Catawba Nuclear Station (CNS), Units 1, and 2
CNS Docket Nos. 50-413, 50-414

McGuire Nuclear Station (MNS), Units 1, and 2
MNS Docket Nos. 50-369, 50-370

Oconee Nuclear Station (ONS), Units 1, 2, and 3
ONS Docket Nos. 50-269, 50-270, 50-287

Technical Specifications Revision Request to Adopt TSTF-490, Rev. 0
"Deletion of E Bar Definition and Revision to RCS Specific Activity"

Figure 3.4.16-1 (page 1 of 1)
Reactor Coolant DOSE EQUIVALENT I-131 Specific Activity
Limit Versus Percent of RATED THERMAL POWER

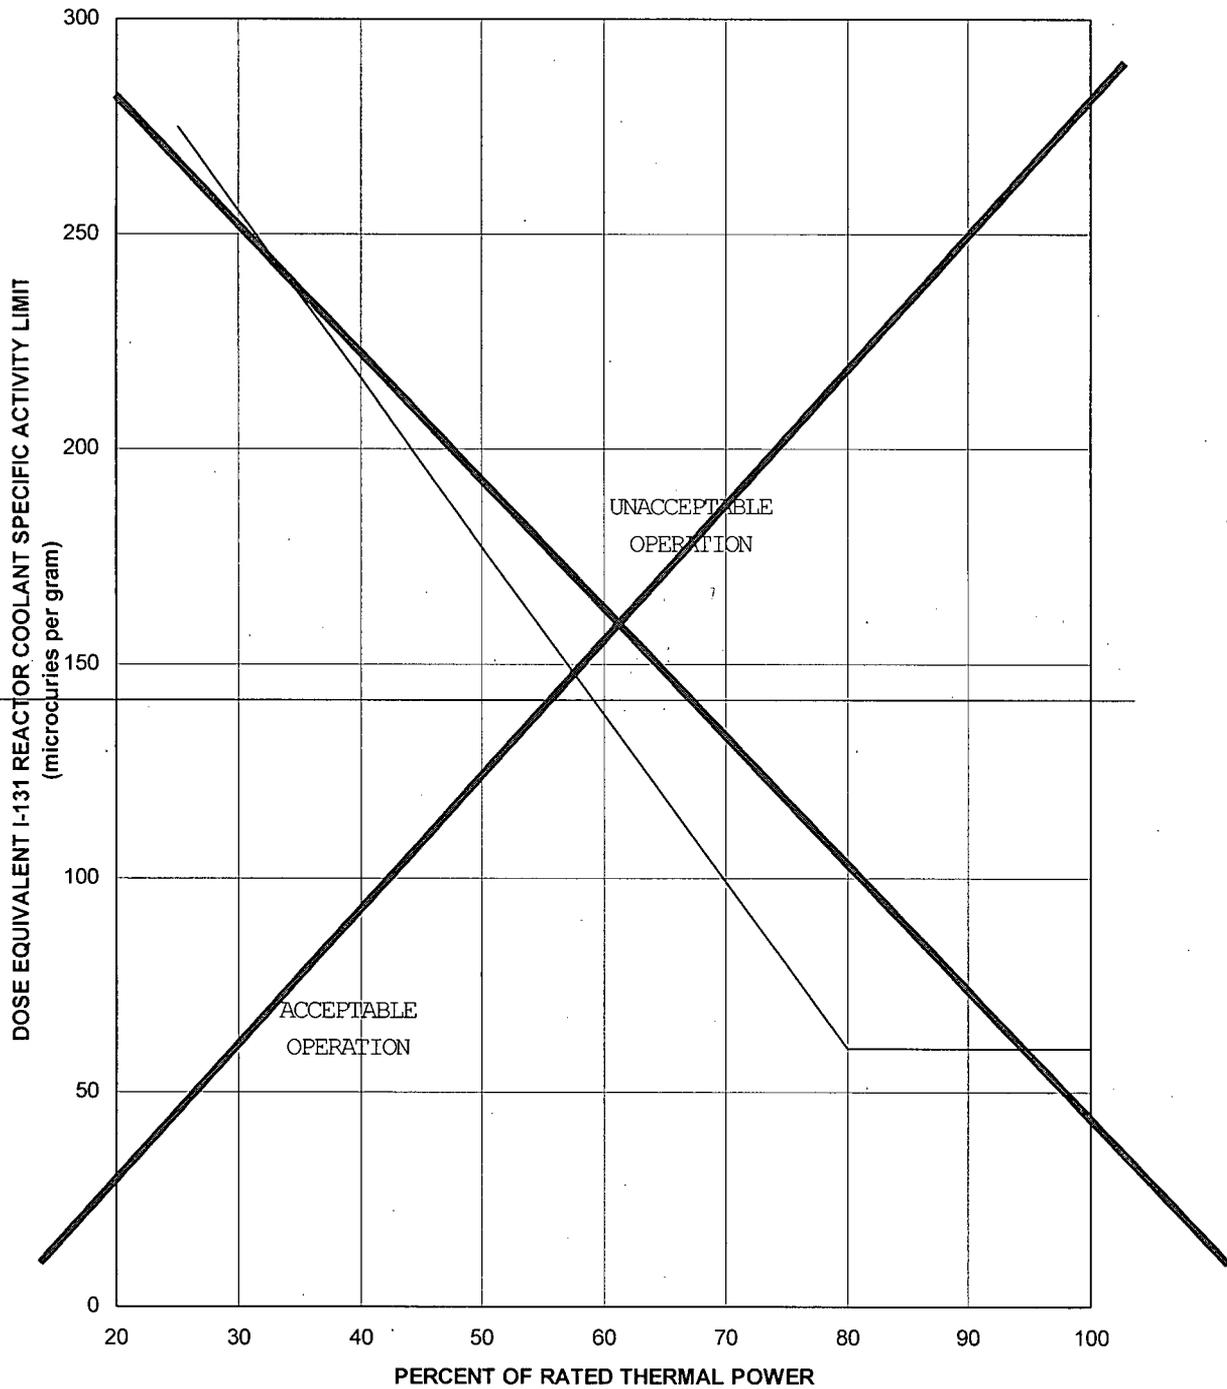
- Revise LCO 3.4.16 (CNS, MNS) and LCO 3.4.11 (ONS), "RCS Specific Activity," to delete references to gross specific activity; add limits for DOSE EQUIVALENT I-131 and DOSE EQUIVALENT XE-133; and delete Figure 3.4.16-1 (CNS, MNS) and Figure 3.4.11-1 (ONS), "Reactor Coolant DOSE EQUIVALENT I-131 Specific Activity Limit versus Percent of RATED THERMAL POWER."

- A. Condition A is modified to delete the reference to Figure 3.4.16-1 (CNS, MNS), Figure 3.4.11-1 (ONS), and define an upper limit that is applicable at all power levels.

Figure 3.4.11-1 (page 1 of 1)
Reactor-Coolant DOSE EQUIVALENT I-131 Specific Activity Limit
Versus Percent of RATED THERMAL POWER With Reactor-Coolant
Specific Activity > 1.0 µCi/gm DOSE EQUIVALENT I-131

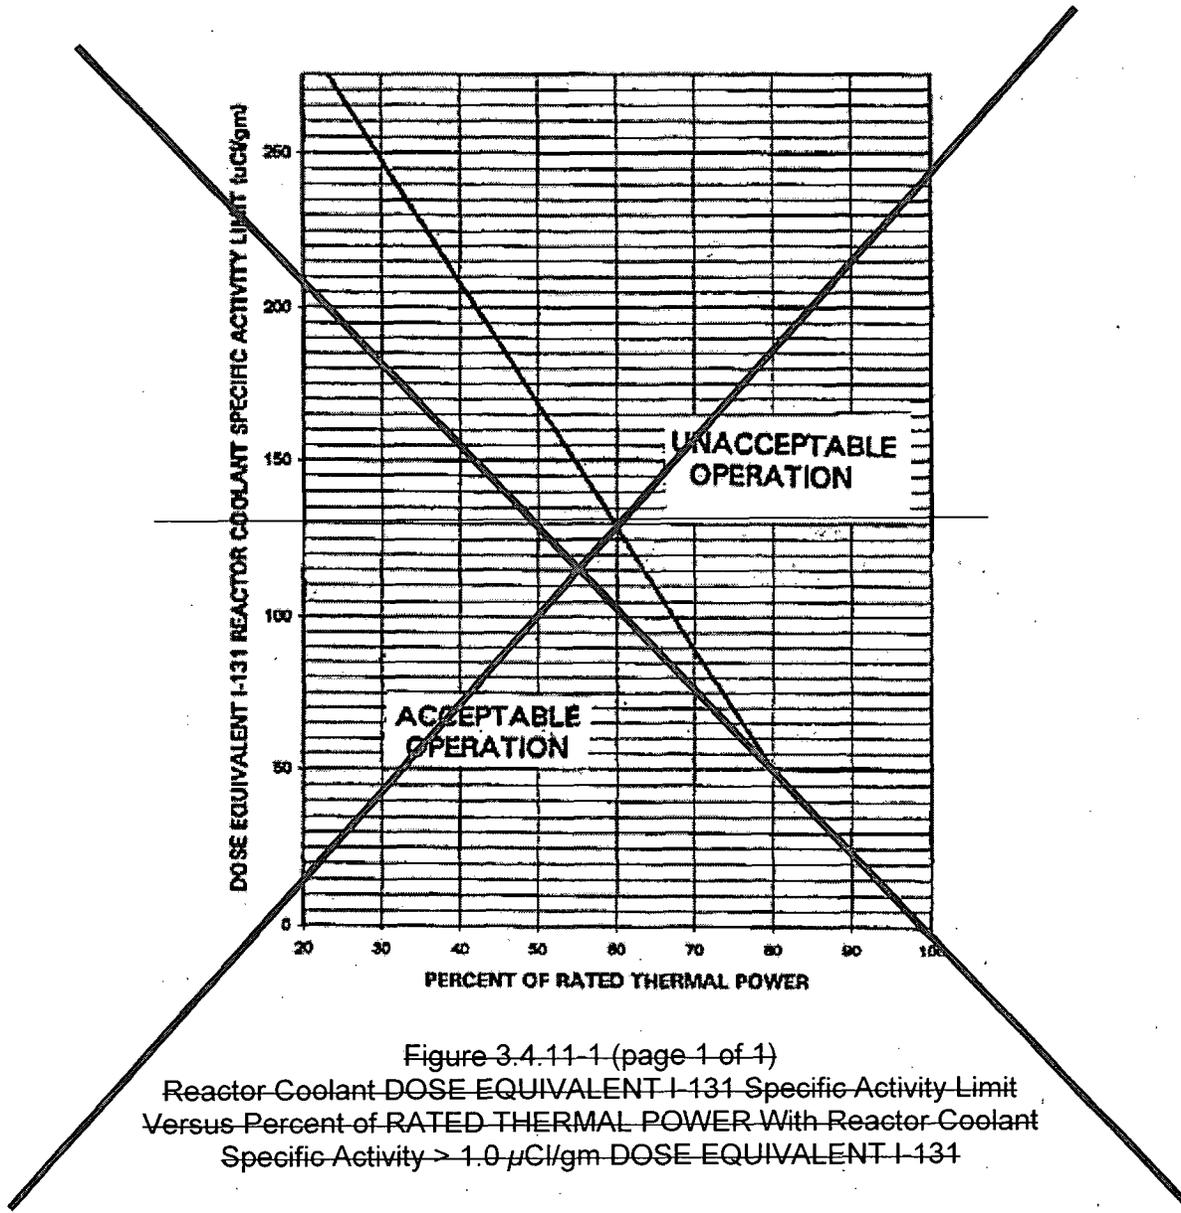
~~The remainder of the above limit permissible iodine levels shown in Figure 3.4.11-1 are acceptable because of the low probability of an SGTR accident occurring during the established 48 hour time limit. The occurrence of an SGTR accident at these permissible levels could increase the site boundary dose levels, but still be within 10 CFR 100 dose guideline limits.~~
